Addendum #1 to Final Environmental Impact Report for the
Glen Mor 2 Student Apartments Project
(SCH# 2010081020)

Project Title: Glen Mor 2 Student Apartments
Project Number: 956334
Project Location: The project is located on the University of California, Riverside (UCR) campus, generally northwest of Big Springs Road and Valencia Hill Drive. The site is south of the existing Glen Mor 1 and Pentland Hills residential complexes and east of Lothian residence hall.
City: Riverside
County: Riverside

Addendum #1 for Glen Mor 2 Student Apartments
Modified Arroyo Improvements
September 25, 2012

Figure 3.3-5b
Arroyo and Jurisdictional Water Impacts (Central Gabion Wall)
Glen Mor 2 Student Apartments
Revised September 2012 for Arroyo Improvements Addendum

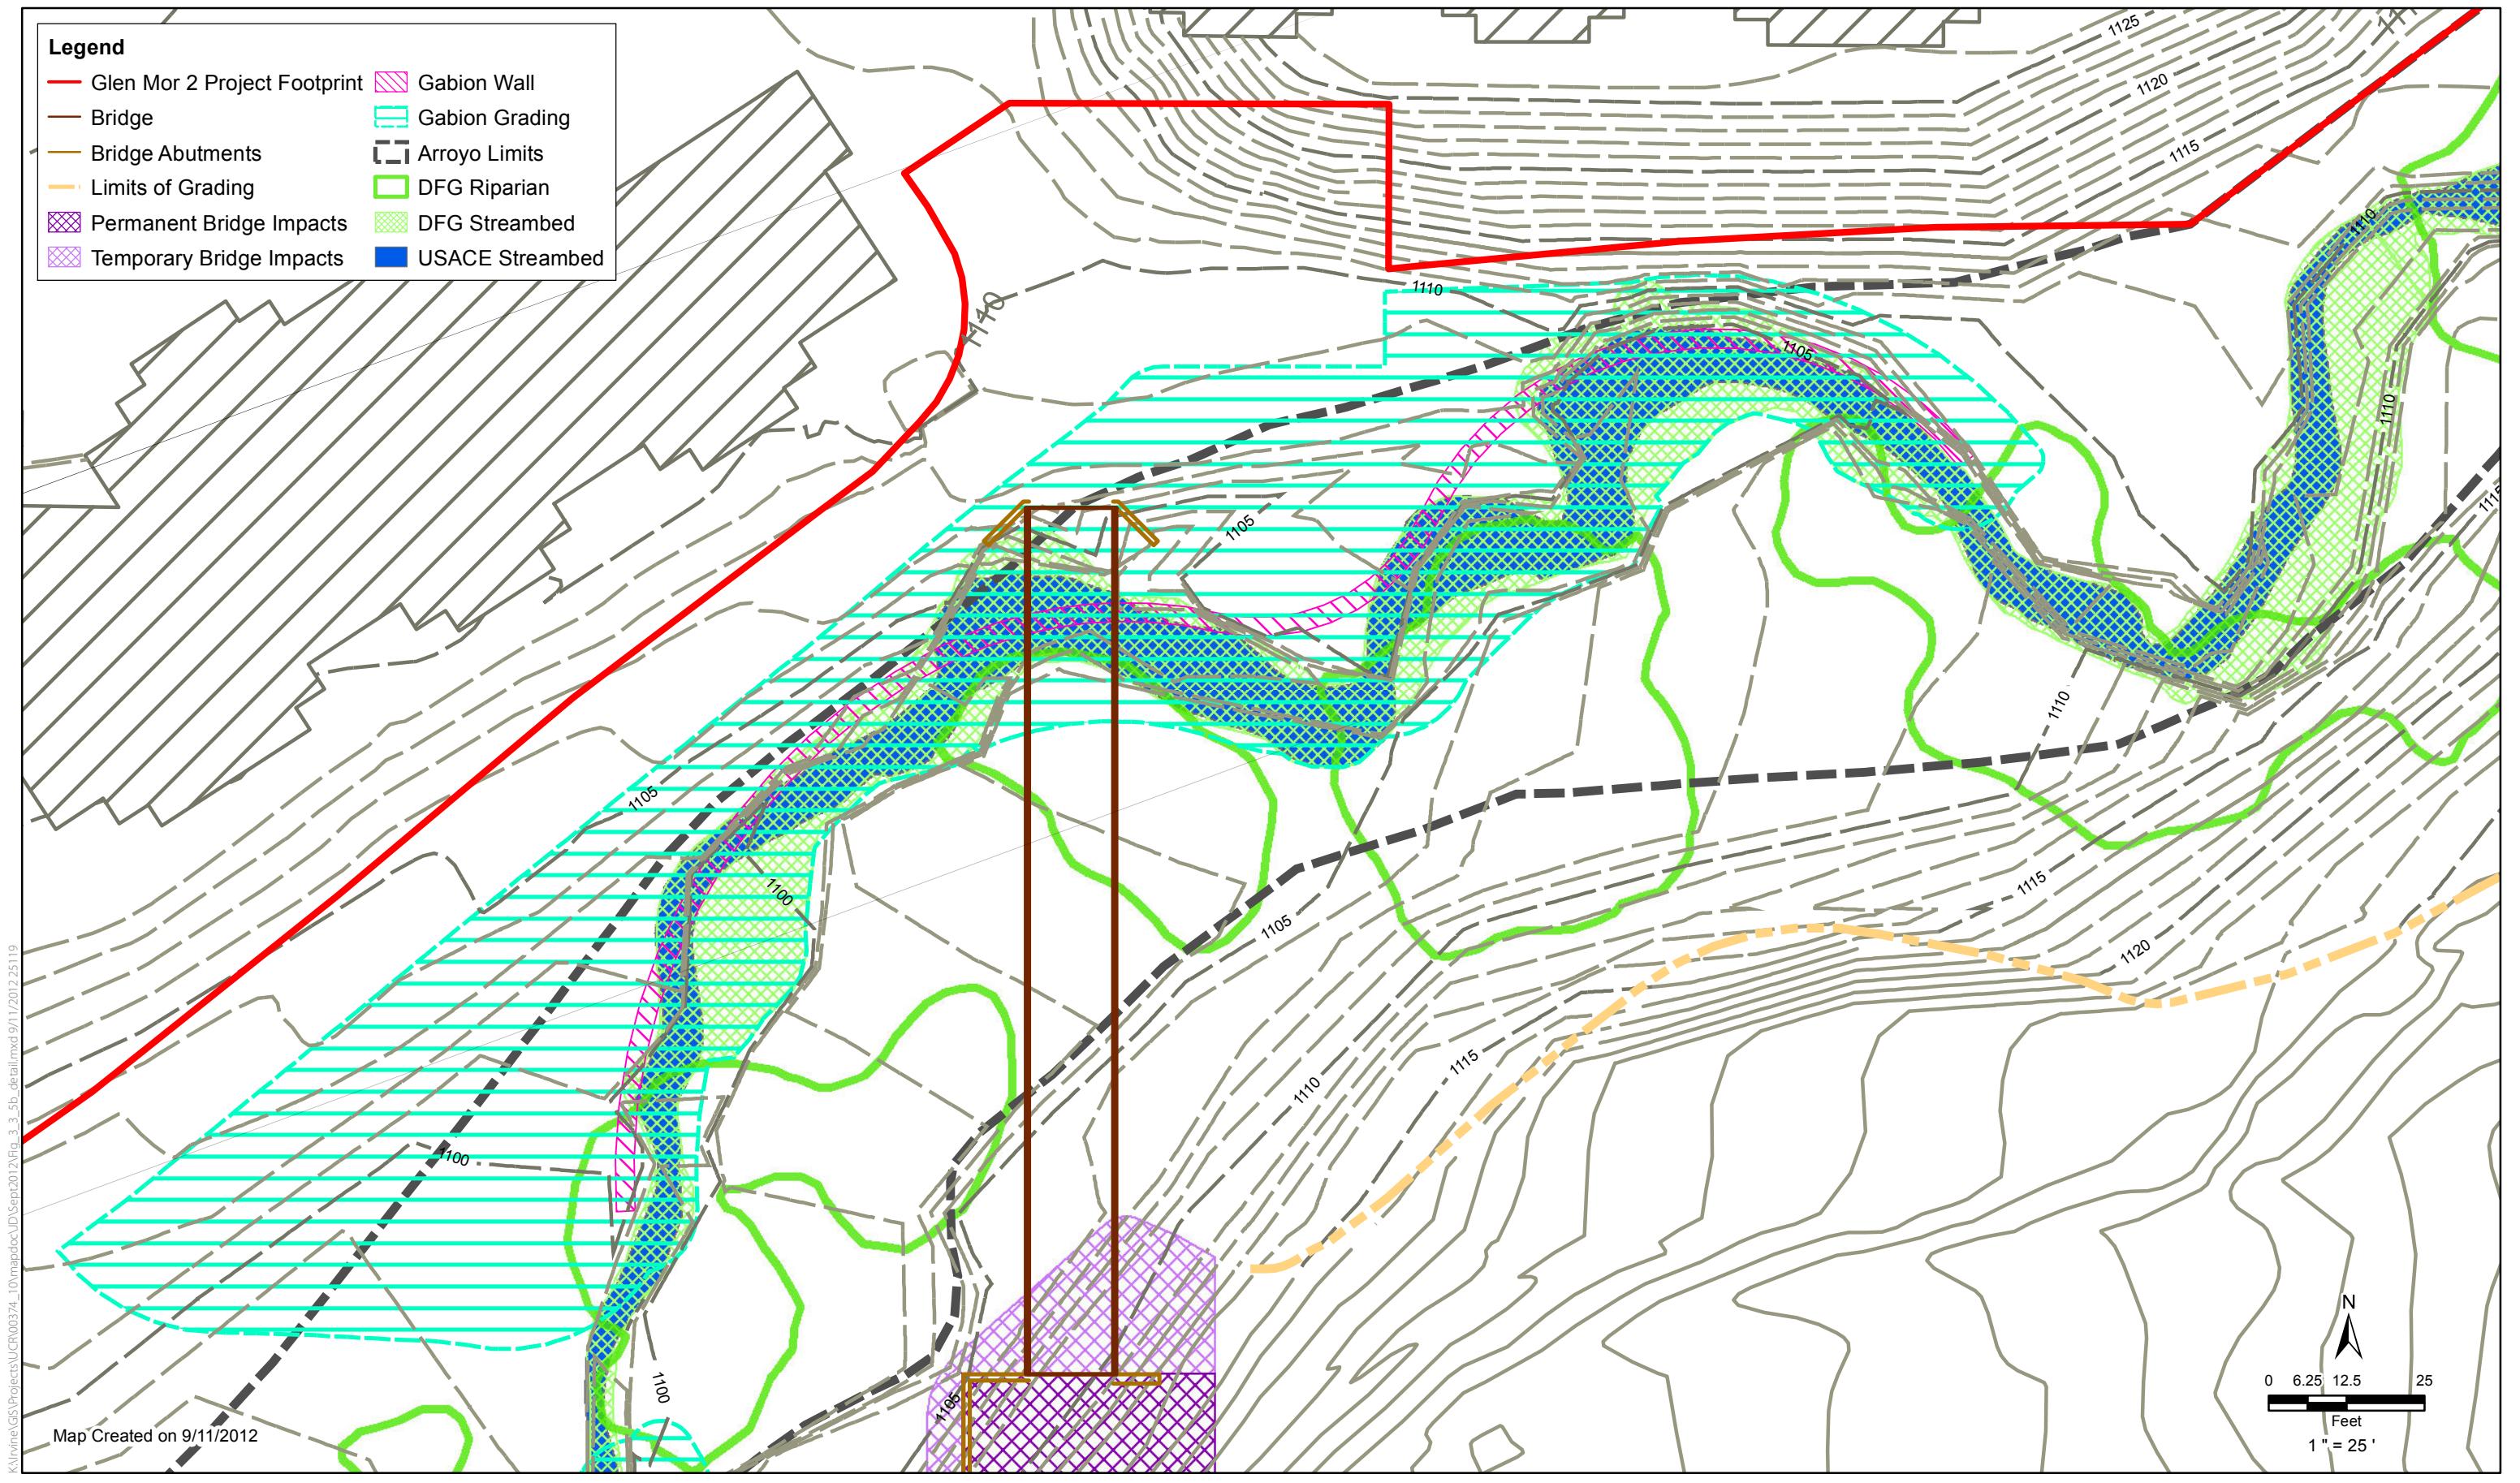
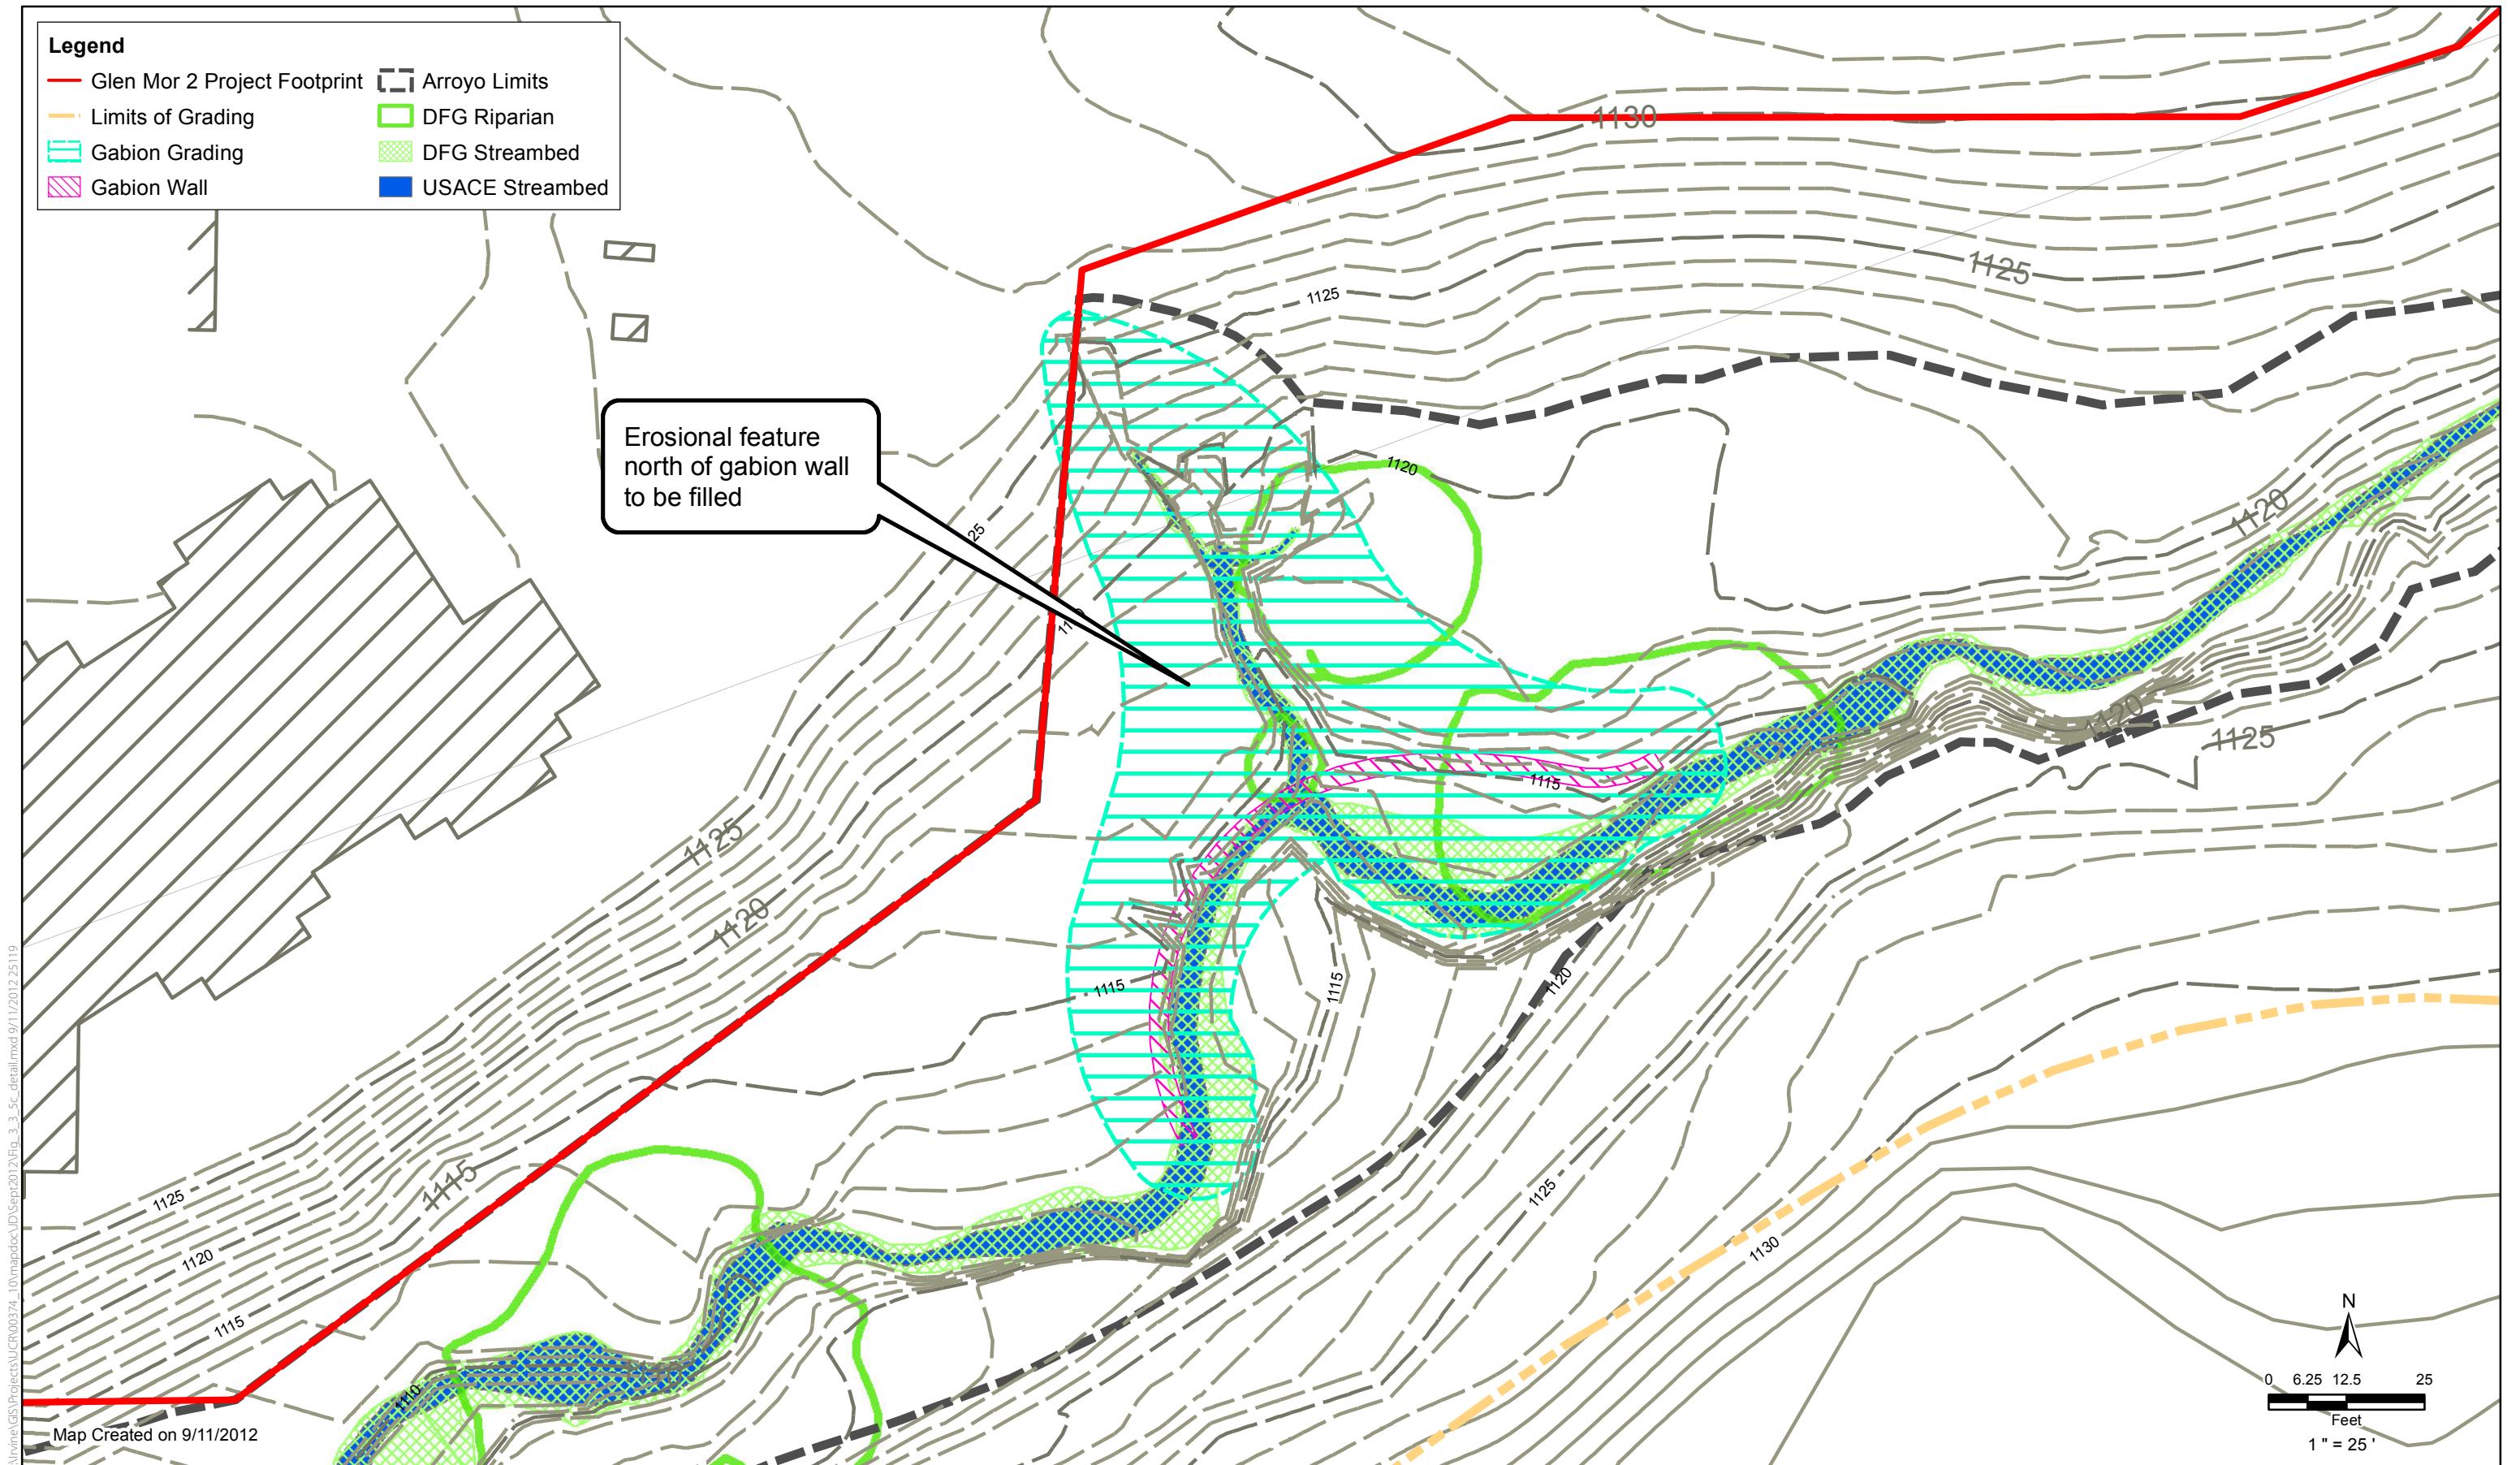
The modified arroyo improvements make several changes in the nature and extent of impacts upon jurisdictional stream resources habitat. An updated evaluation of impacts upon jurisdictional resources, was conducted for the modified improvements. The results are summarized in the attached updated Table 8 (replaces Tables 8 on page 5-17 of Appendix I in Volume 3 of the certified EIR). The relationship of proposed improvements to mapped jurisdictional resources is illustrated in the attached updated Figure

3.3-5, including new detail figures 3.3-5a, 3.3-5b, and 3.3-3c (replaces Figure 3.3-5 following page 3.3-8 of the Draft EIR Volume). Impacts are increased, typically by factors of two to three times for all components, except impacts to DFG riparian. Despite the magnitude of the increases, the overall magnitude of impacts remains limited, with total temporary impacts to approximately 0.12 acre of waters of the United States (844 feet of streambed) and 0.45 acre of DFG jurisdiction (825 feet of streambed), and permanent impacts to approximately 0.03 acre of waters of the United States (373 feet of streambed) and 0.05 acre of DFG jurisdiction (467 feet of streambed). The increased impacts primarily arise from the added gabion wall components and the associated temporary excavation limits. The requirements under Mitigation Measures BIO 3 through 7 ensure that impacts are minimized and that finished conditions include replacement plantings of similar type and acreage. The proposed modifications to Mitigation Measures BIO 3 and BIO 4 merely elaborate on aspects related to a specific tree and do not alter the conclusion as to significance of impacts after mitigation. Considering the limited magnitude of impacts, together with the minimization and compensation measures provided for in the adopted mitigation monitoring and reporting program, the modified arroyo improvements do not present the potential for new significant impacts or a substantial increase in the severity of previously identified impacts to jurisdictional water resources. LRDPEIR PP 4.4-2(a), LRDPEIR mitigation measure 4.4-3(a), and project-level mitigation measures BIO 3 through BIO 7, will continue to apply, in accordance with the adopted Mitigation Monitoring and Reporting Programs for both the LRDPEIR and the Glen Mor 2 project (as amended by this Addendum).

Figure 3.13-2
Construction Haul Routes
Glen Mor 2 Student Apartments
Revised September 2012 for Arroyo Improvements Addendum

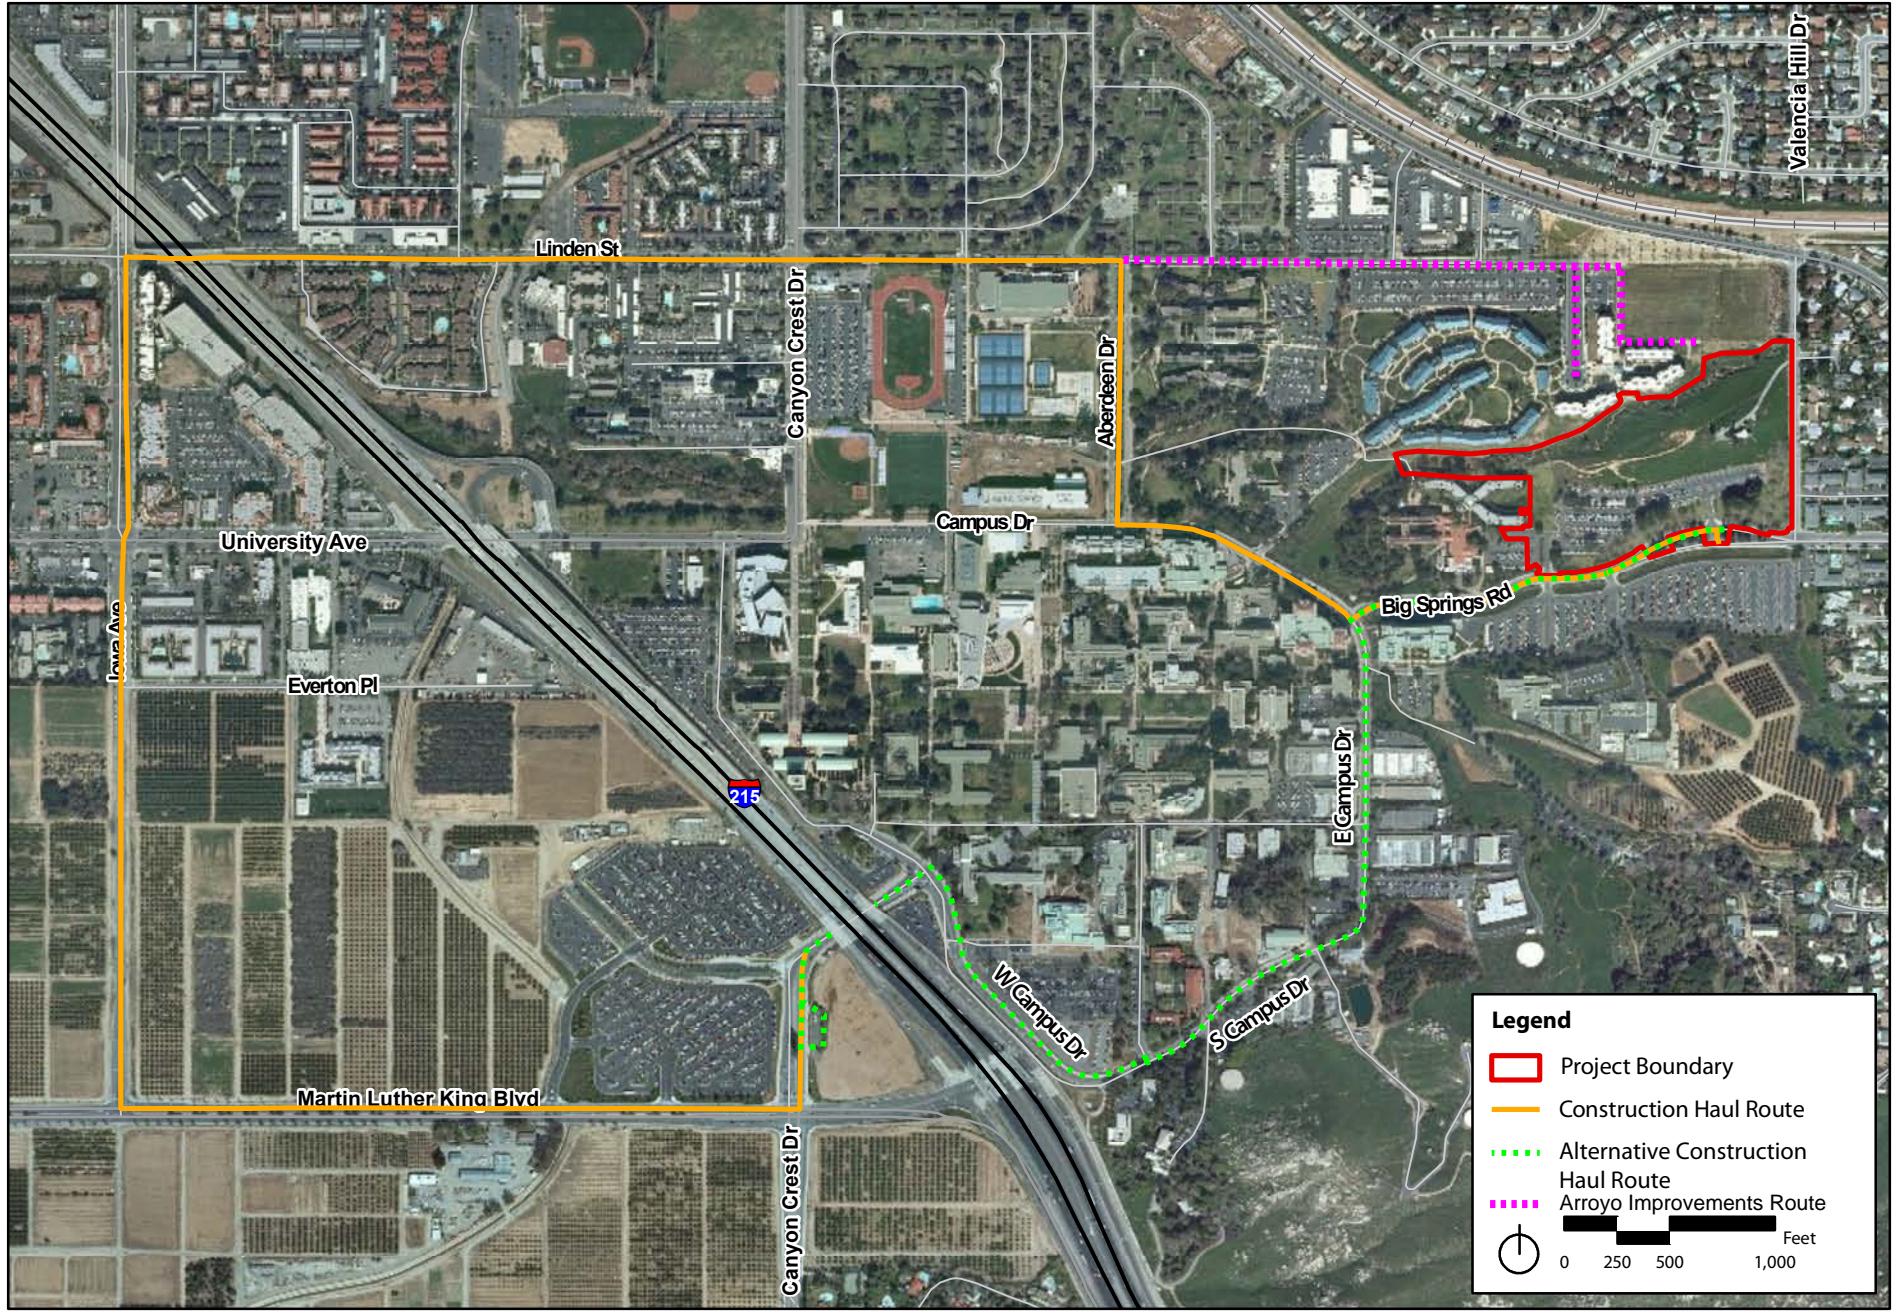
fields (see revised Figure 3.13-2 attached hereto). The receptors located along this route are similar to those considered in the EIR analysis and the level of activity will be more limited (240 total truck trips for duration of construction versus the 178 trucks per day assumed in the EIR). On this basis, the proposed project modification does not present the potential for new significant impacts or substantial increase in the severity of previously identified impacts.
